# PERMIT

SEWAGE DISPOSAL SYSTEM

PROPERTY OWNER Wiesinger, Lawrence

RE: B. P. #36569  
Proposed Garage/Studio Addition  
13886 Clarksville Pike

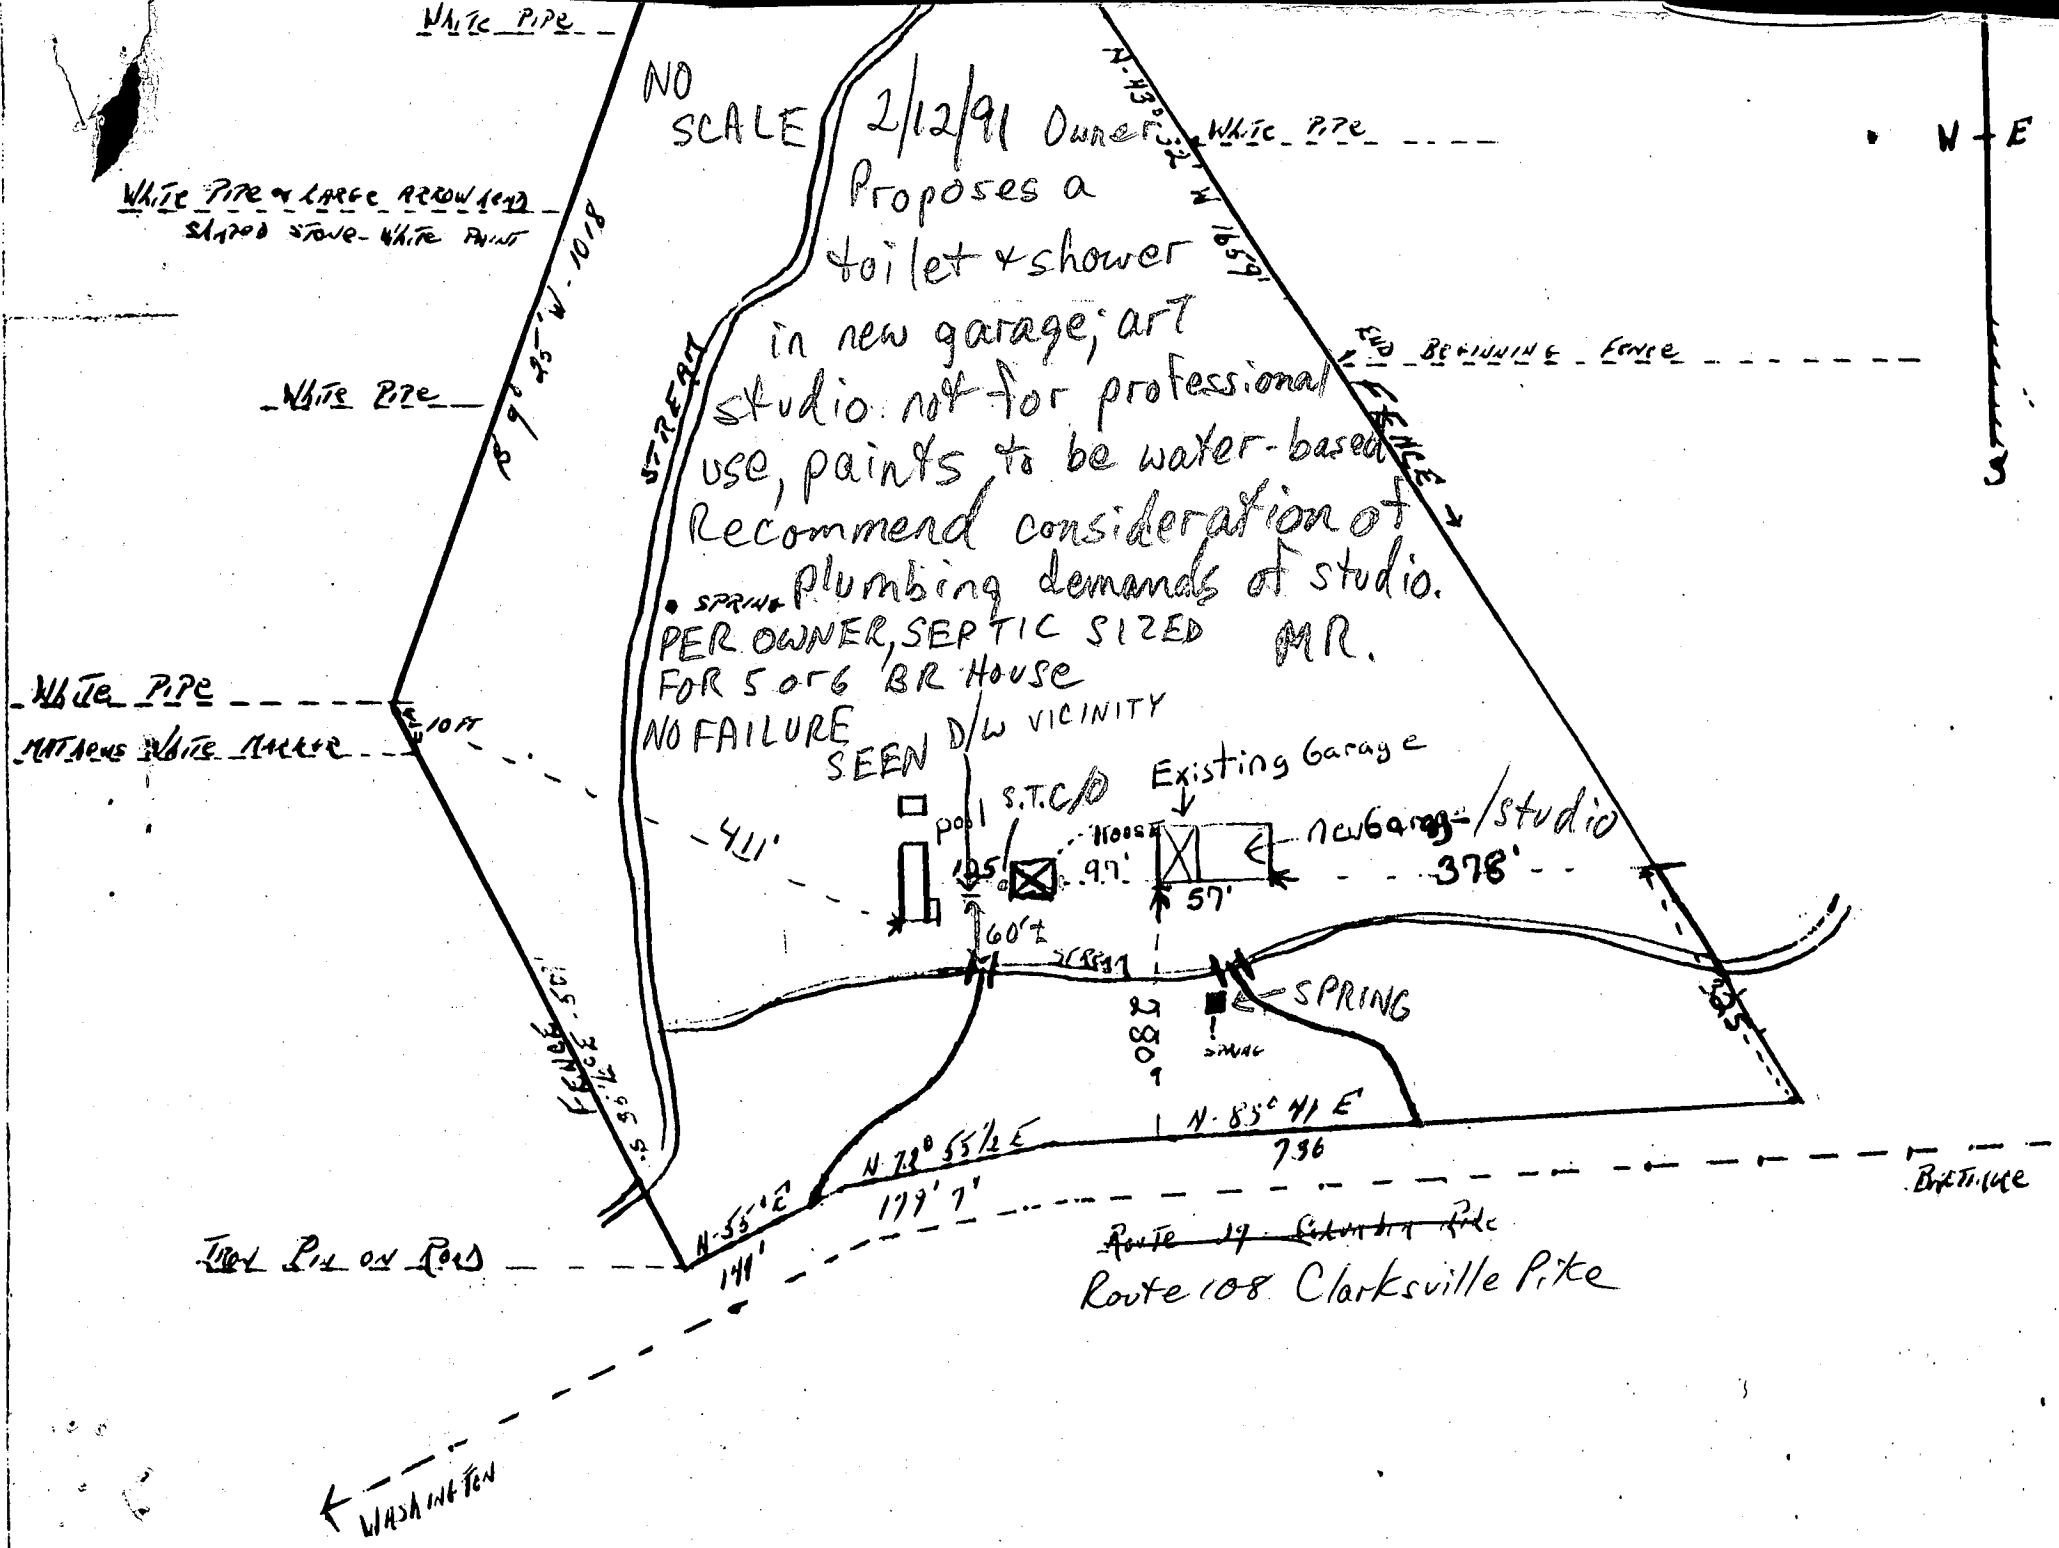
2/12/91 Owner

Proposes a toilet & shower in new garage; art studio not for professional use, paints to be water-based

Recommend consideration of plumbing demands of studio.

PER OWNER, SEPTIC SIZED FOR 5 OR 6 BR HOUSE  
NO FAILURE SEEN D/W VICINITY
